August 28, 1986
ST-HL-AE-1710
File No.: C12.188/G9.1

South Texas Project
Units 1 and 2
Docket Nos. STN 50-498, STN 50-499
FSAR Changes Related to Deletion of
Containment Spray Sump Additive Tank

Attachment: Annotated FSAR Pages to Section 6.1.1, 6.1.3, 6.2.2, 6.5.2, 7.6, 15.6.5, Tables 6.4-2 and 7.1-2, Figures 6.5-1 and 7.6-9, and NRC Questions 22.11, 122.20, 312.07, 12 & 13.

Insert X (pg. 6.5-9)

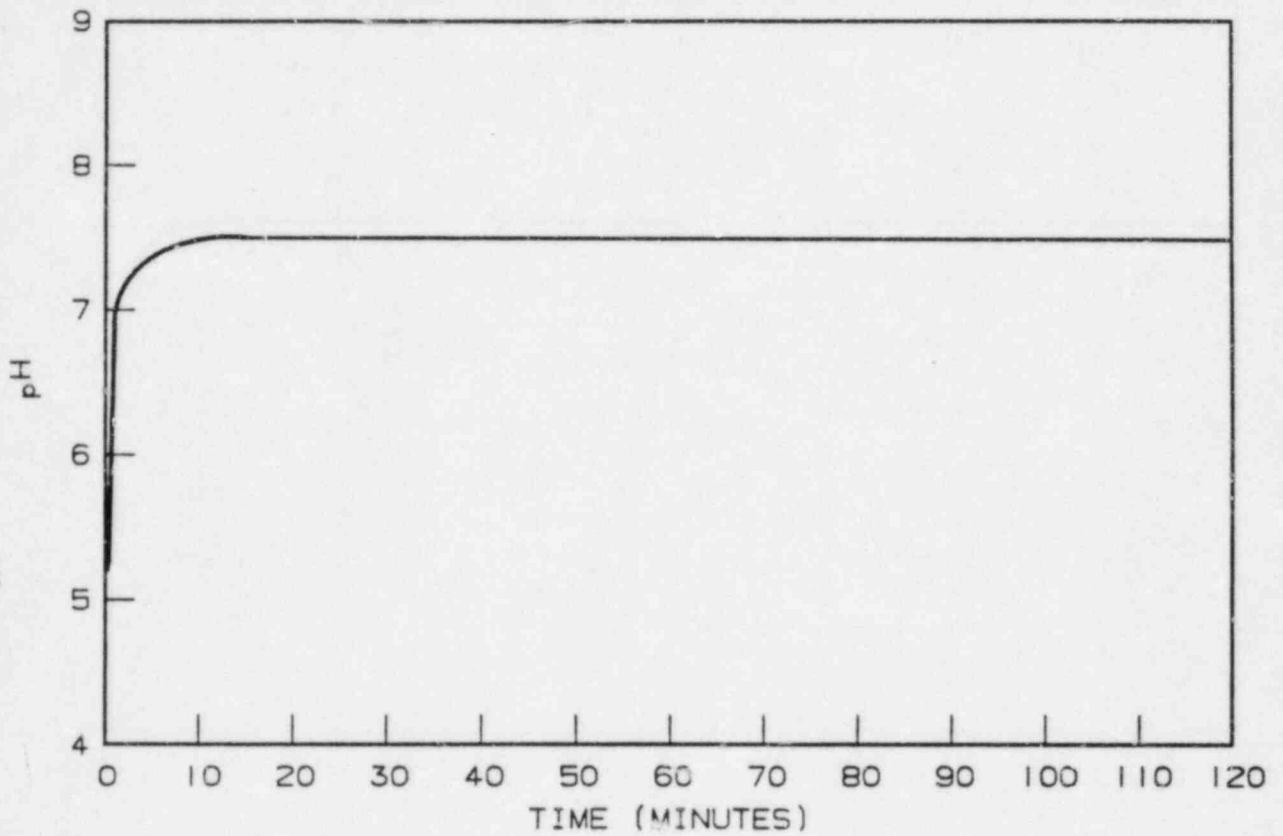
Following a design basis steam line ^{always alkaline} break inside the Containment, the pH of the water in the Containment sump is ~~never less than 7.0~~ due to the secondary side water having a specified minimum pH of 8.8. The addition of a sodium hydroxide solution via the Containment Spray System increases the pH. The maximum pH will be less than 10.5, which is the maximum spray pH during injection.

Figure 7.6-9

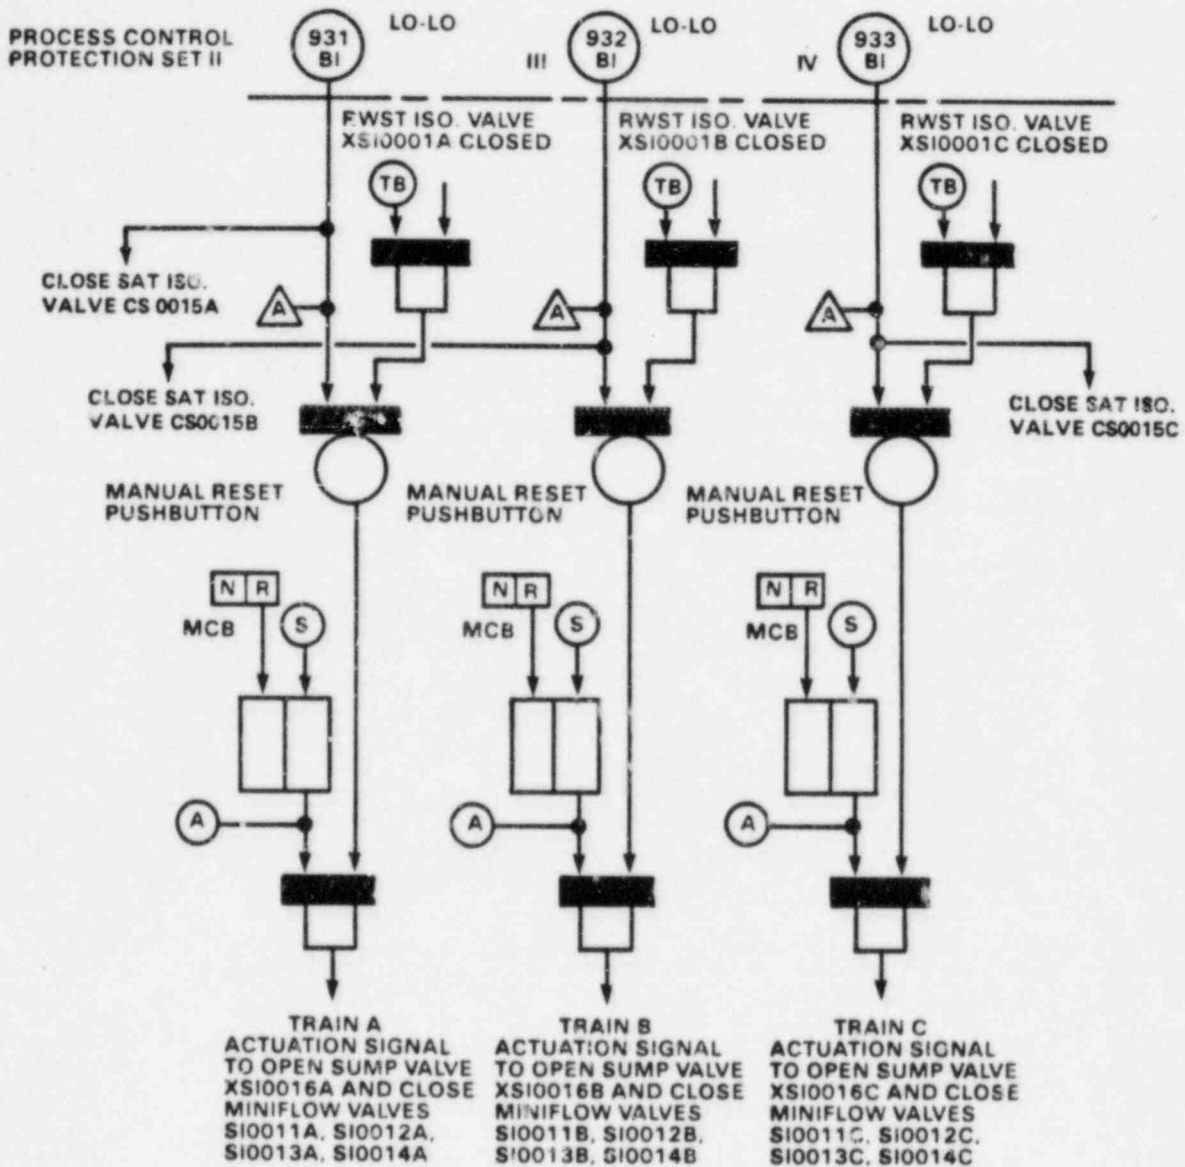
(During the switchover, the spray additive tank isolation valves are closed by the RWST low-low level signal when the MCB switches are in the auto position (refer to Figure 7.6-14 for the logic 7.6-5 diagram). Amendment 43

The logic diagram for the spray additive tank isolation valve is shown on Figure 7.6-14. When the main control board switch is in the AUTO position, each valve is opened upon receipt of the containment spray actuation signal; the valve is closed upon receipt of the spray additive tank low-low level signal.
